AERONAUTICAL CHARTING FORUM
Charting Group
Meeting 10-01 – April 2010

RECOMMENDATION DOCUMENT

FAA Control # 10-01- 229

Subject: Charting Approach Procedures Based On Order 8260.3B (TERPS), Change 20 for Continuous Descent Final Approach (CDFA) Harmonization

Sample NACO Chart with CDFA Notation

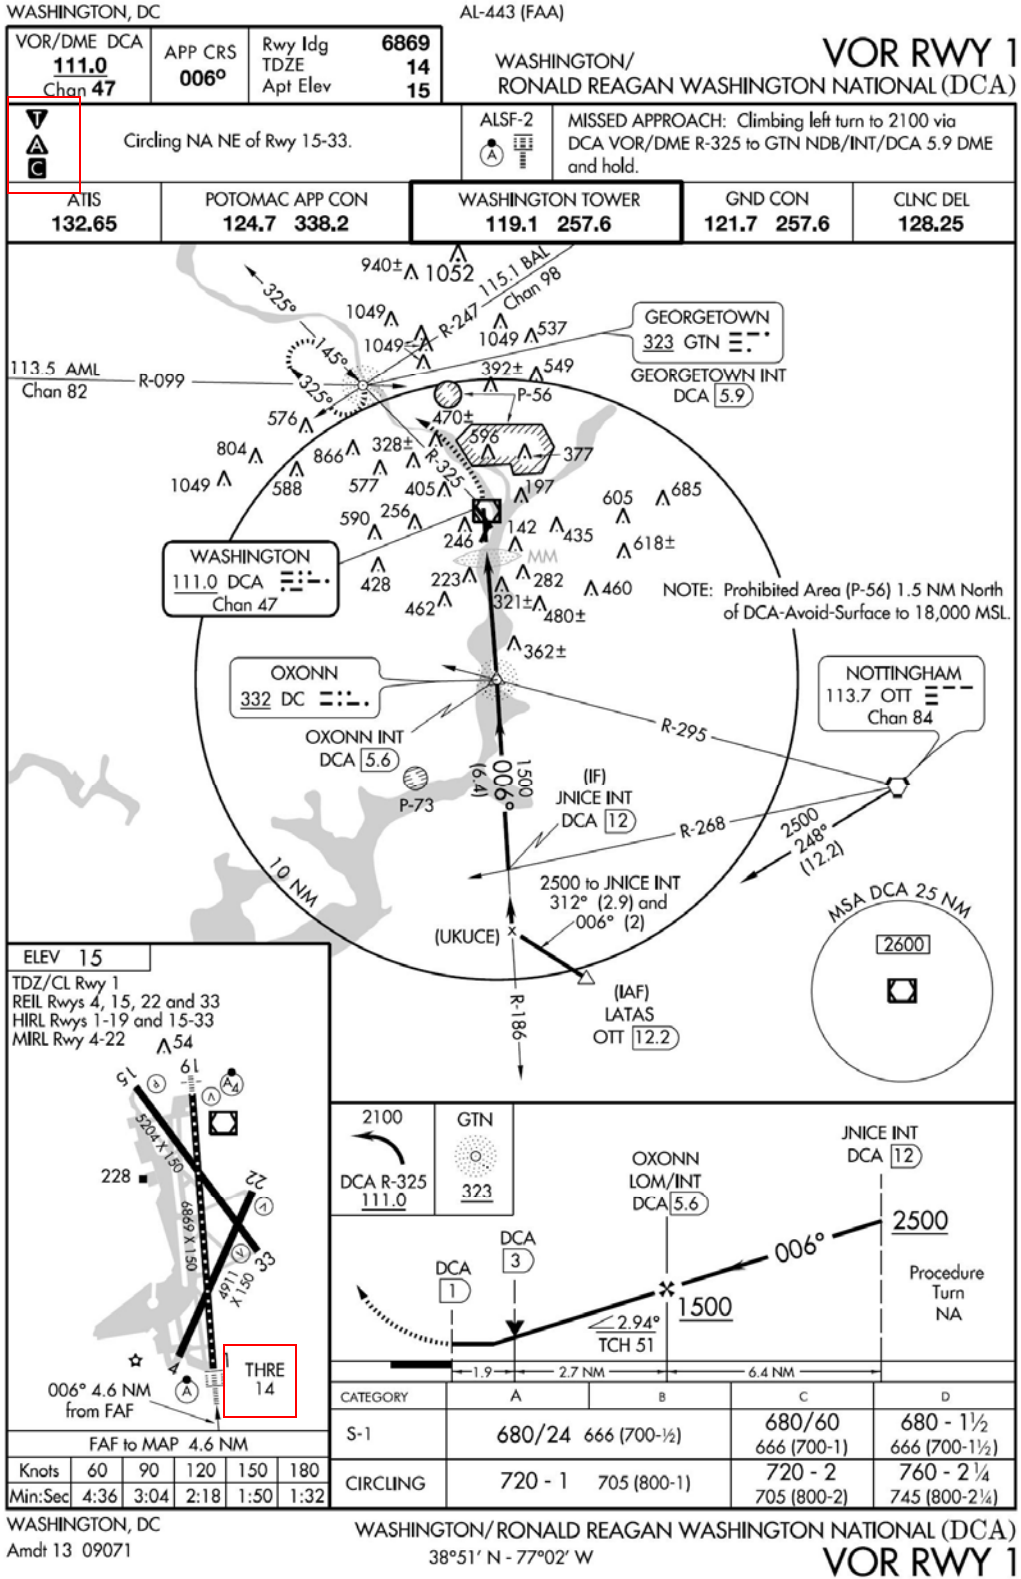
Recommendations: To assist in the rapid identification of procedures which require a visibility penalty for operators who do not use a CDFA technique, we propose that all procedures with one or more line of straight-in non-precision approach minima based Order 8260.3B (TERPS), Change 20 criteria display a CDFA icon in the chart notes. Circling-only approach procedures do not require this notation. This icon should be similar to the icons used to identify nonstandard takeoff or alternate minima, with a description of the iconography also added to the legend:

If required by OpSpec, MSpec, or LOA, add 1/8 sm or 700 ft to CAT A and B visibility/RVR minimums, and add 1/4 sm or 1300 ft to CAT C and D visibility/RVR minimums. Visibility penalty does not apply when using a continuous descent final approach (CDFA) technique.

Comments: This recommendation will affect all procedures with one or more line of straight-in non-precision approach minima based Order 8260.3B (TERPS), Change 20 criteria. A sample NACO approach charts showing a non-precision approach chart is attached to this recommendation document.
